Technical Newsletter

#tnl2024-0011e
1 / 2

Follow-up Report Regarding Change of DFL7161 Chiller in Response to Various Countries' Refrigerant Regulations

Chiller change

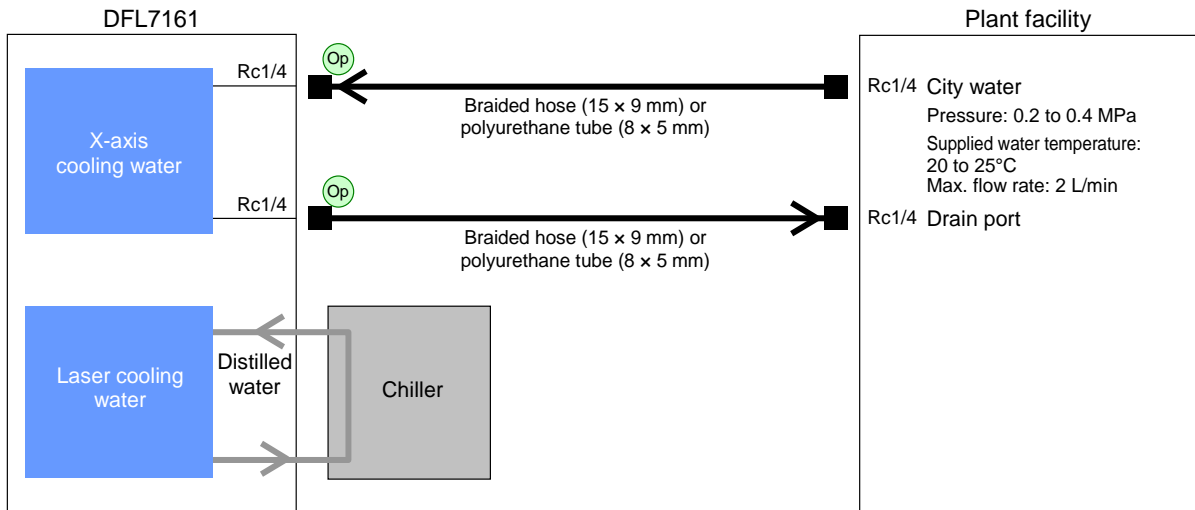
The chiller will change to a chiller with an electronic cooling system that does not use chlorofluorocarbons.

Existing chiller (products affected by regulations)	Changed chiller (products not affected by regulations)
Parts Number	DGMAVEQXC03-0 to DGMAVEQXC03-2	• LPRN-030038-0 (Control unit) • LPRN-030037-0 (Cooling unit)
Cooled system	Air-cooled type	Water-cooled type
Chlorofluorocarbons	Used	Not used

Change to facilities

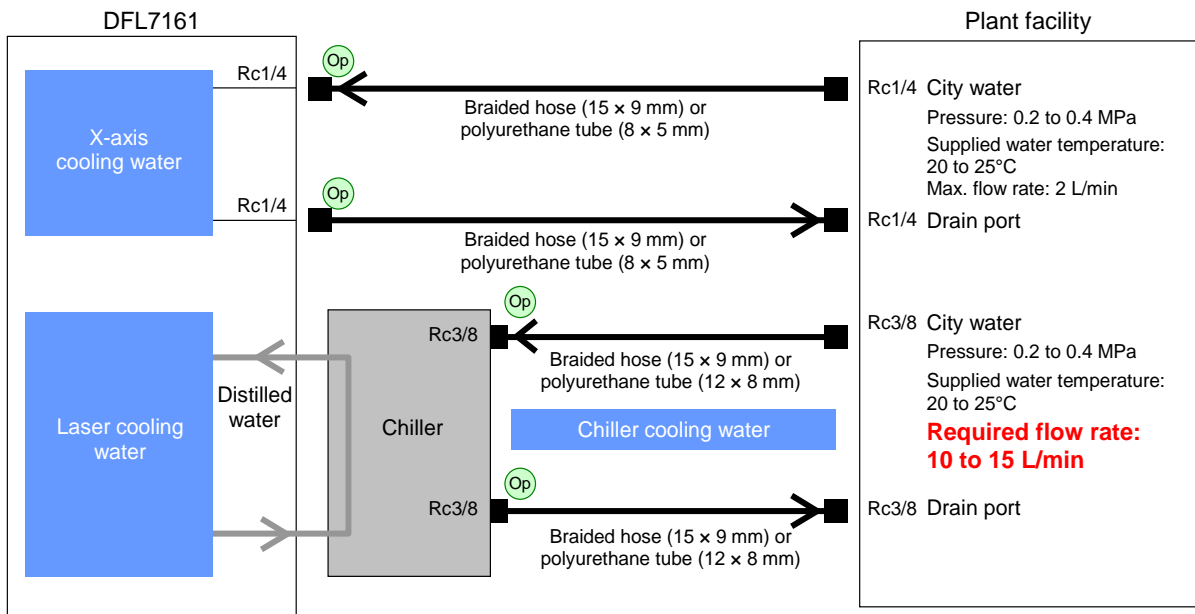
We are contacting you with this technical newsletter with additional information that some changes will be necessary to your plant facilities if you are using a chiller after the change.

■ Before Chiller Change

■ After Chiller Change
